### ADDENDUM NO. 3

nebraskaGlobal Fourth Floor Interior Finish & Remodel  
 Lincoln, Nebraska  
 792-001-11

Addendum #3  
 Supplemental Drawing: SDM01  
 Revision of Sheet: M1.1  
 February 17, 2012

# PARTIAL FOURTH FLOOR HVAC PLAN

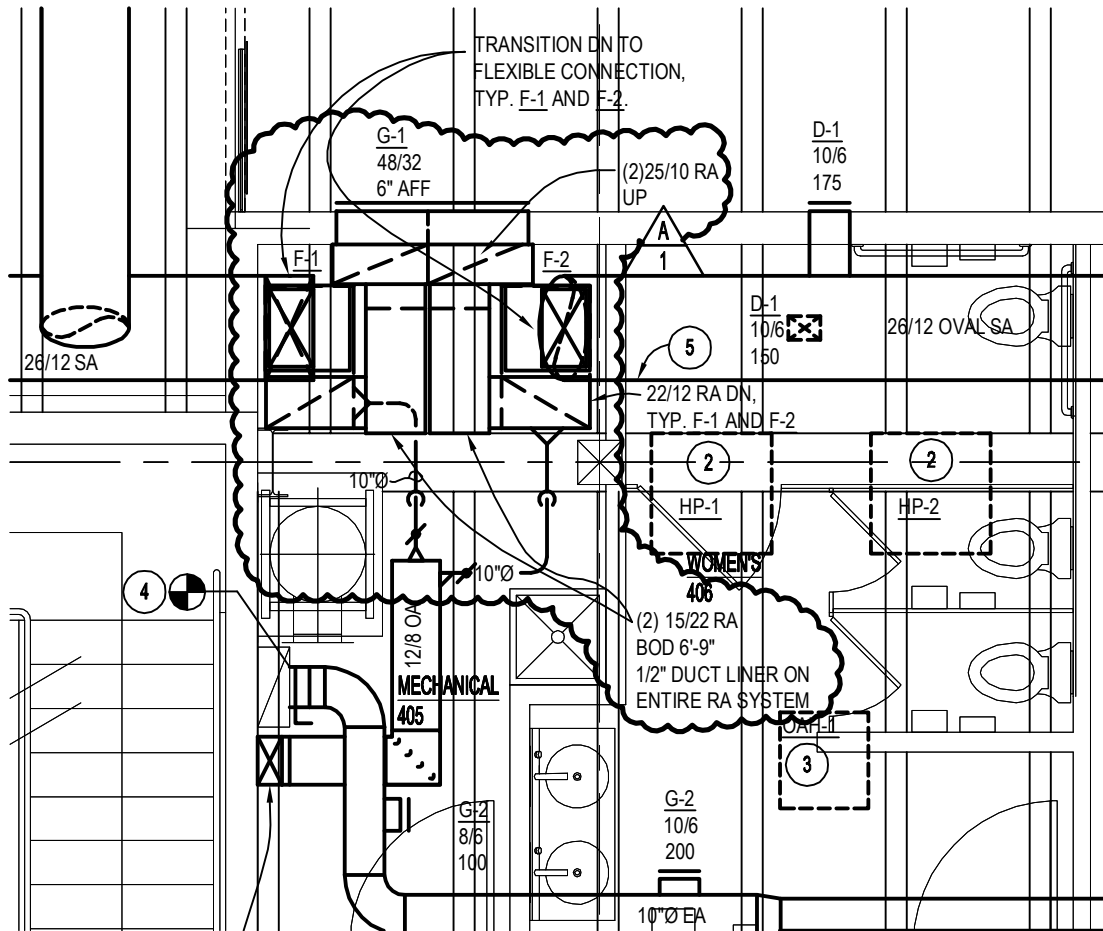
##### Item 3-1: Sheet M1.1 – Mechanical Fourth Floor HVAC Plan

Revise the common return air duct supplying F-1 & F-2 to be independent returns to each fan coil, reference SDM#01 for further information. Note: G-1 serving F-1 & F-2 has been changed to a 48x32 RA grille and there has been (2) 10"Ø OA ducts added to supply each of the independent returns on F-1 & F-2.

F-1 & F-2 are bottom return fan coil units and shall be mounted on a RA plenum base. The approximate base dimensions are 22" deep x 18" tall x 36" long, the mechanical contractor can the coordinate length as necessary to tie the RA ductwork down into the plenum base. All RA shall have ½" lining as specified. Provide vibration protection between the plenum base and fan coil unit bottom, this shall be a 1" foam gasket. Construct the RA plenum base in a manner that it is capable of supporting the fan coil weight (250lbs approximately).
